SOIL/SITE EVALUATION
for ON-SITE WASTEWATER SYSTEM

Owner: Mark E. Teague
Applicant:
Address: 6516 Glenn Teague Rd., Charlotte, N. C. 28216
Date Evaluated: 2/18/02
Proposed Facility: Residence
Design Flow (.1949): 360gpd
Property Size: 1.61a
Location of Site: 6500 Glenn Teague Road
Property Recorded: 1994
Water Supply: [x] Public [ ] Individual [ ] Well [ ] Spring [ ] Other
Evaluation Method: [x] Auger Boring [ ] Pit [ ] Cut
Type of Wastewater: [x] Sewage [ ] Industrial Process [ ] Mixed

PROPOSED PLOT PLAN

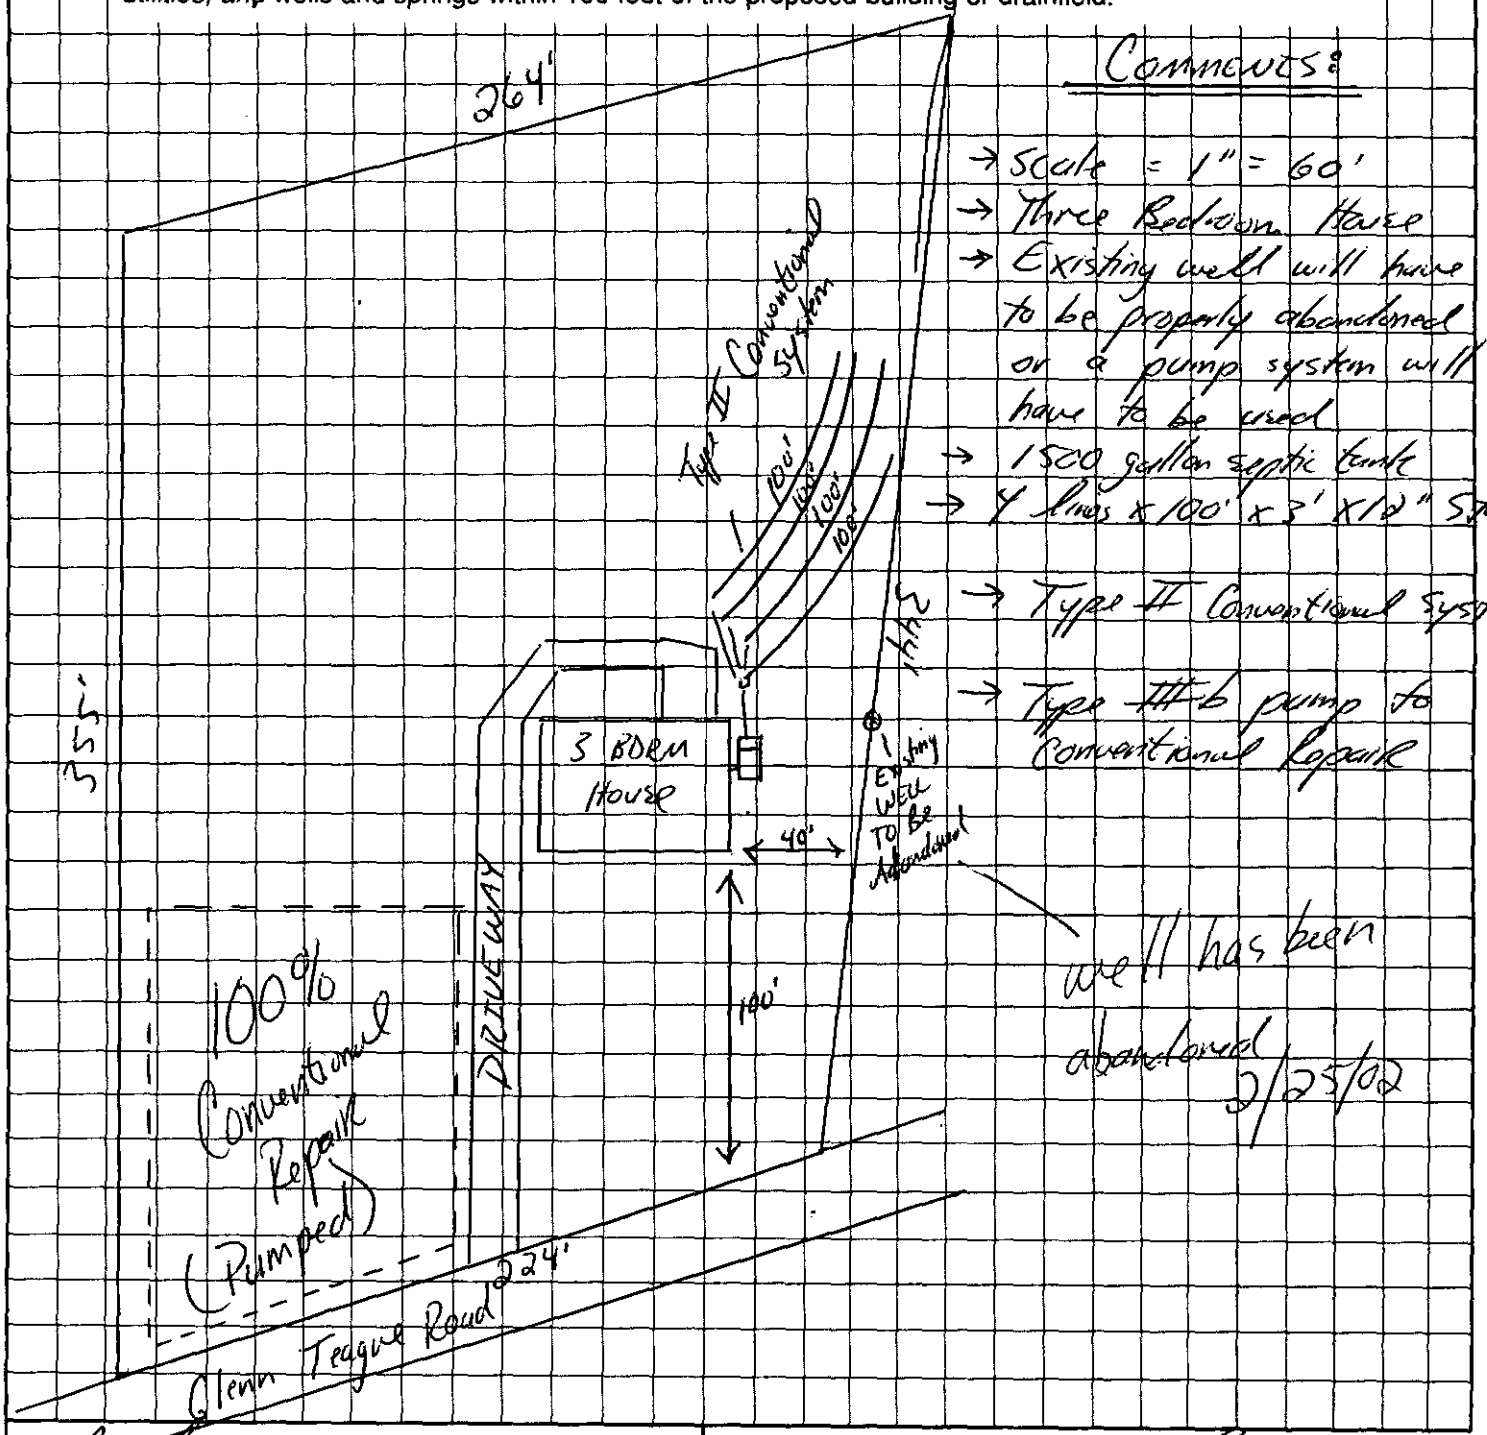
→ Scale = 1" = 60'
→ Three Bedroom House
→ Existing well will have to be properly abandoned or a pump system will have to be used
→ 1500 gallon septic tank
→ 4 lines x 100' x 3' X 12" Stone
→ Type II Conventional System
→ Type III-b pump to Conventional Repair

well has been abandoned 2/25/02
